WESTCONNEX M4-M5 LINK EIS

PEER REVIEW OF TRAFFIC AND TRANSPORT ASSESSMENT AND ACTIVE TRANSPORT ASSESSMENT

FOR
DEPARTMENT OF PLANNING AND ENVIRONMENT

Issue date: 12th March 2018

Figure 4.1: AM Peak Comparison of Google Traffic Speeds and EIS-reported LoS

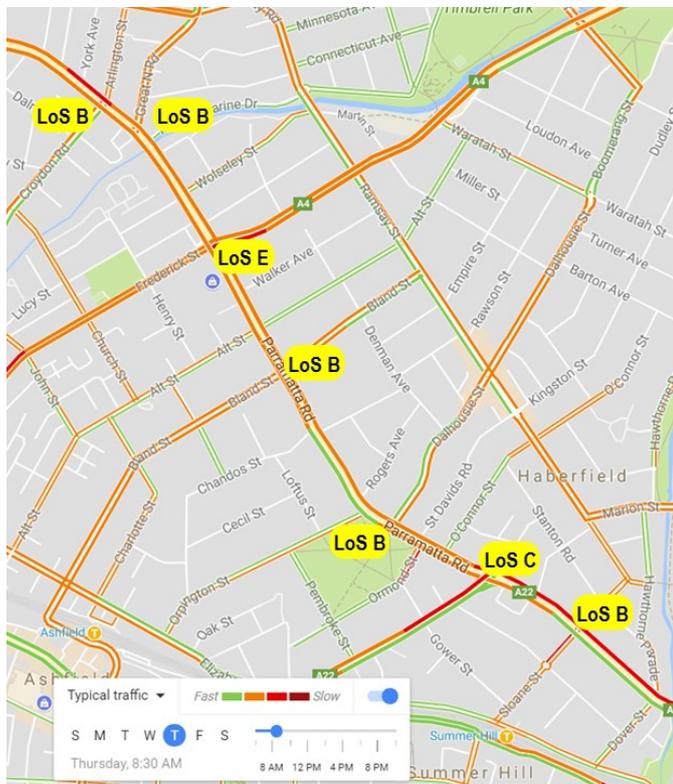
These findings (presumably from the microsimulation modelling) are inconsistent with site observations and with Section 6.2.1 of the report which states '*The Parramatta Road corridor currently functions under high levels of traffic demand, with the demand often exceeding the capacity of the road, especially eastbound during the AM peak period. This results in congested conditions and long queues and delays during peak periods*'. It would be expected that a number of intersections in this section would be operating at LoS D/E/F in the AM peak with some intersections operating at LoS E/F in the afternoon peak as well.

Figure 4.1 provides a comparison of 2017 AM peak traffic speeds from *Google Traffic* versus EIS-reported 2015 peak LoS at key intersections.

Figure 4.2: Google Traffic Speeds at Ricketty Street/Kent Road

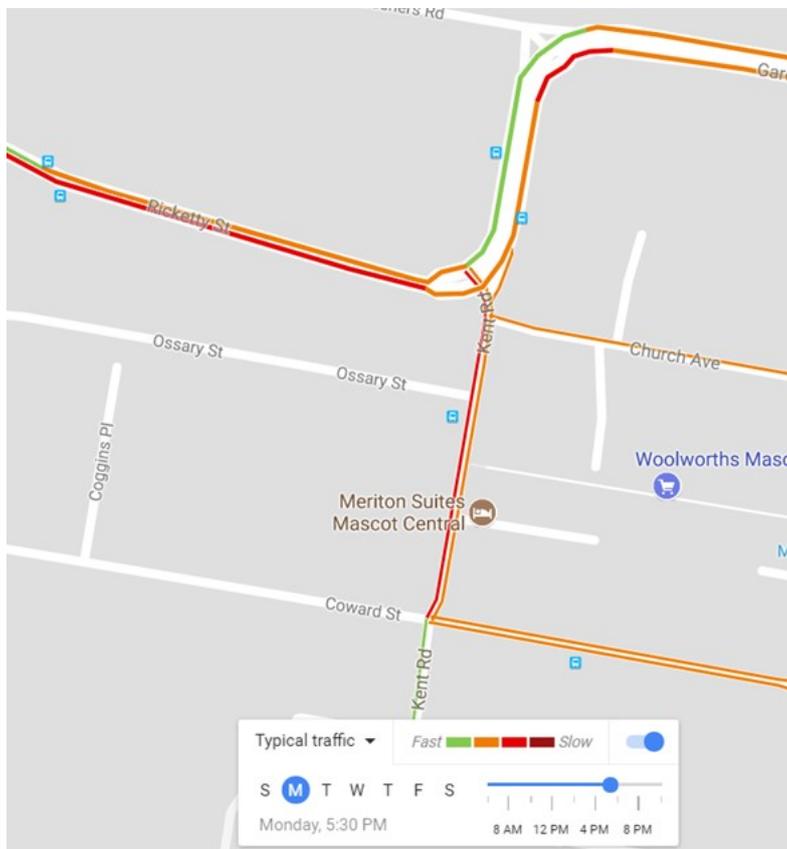
The Ricketty Street/Kent Road intersection which experiences over-capacity conditions for at least two of its three approaches in the PM peak (i.e. the Kent Street approach and the Right turn from Ricketty Road into Kent Street) is reported as LoS A in both peaks. The *Google Traffic* performance of this intersection in the 2017 PM peak is shown in Figure 4.2.

The EIS would have benefitted from providing further evidence of actual and modelled intersection traffic volumes and delay comparisons for each peak period to verify the suitability of the calibrated/validated models as the basis for future year assessments
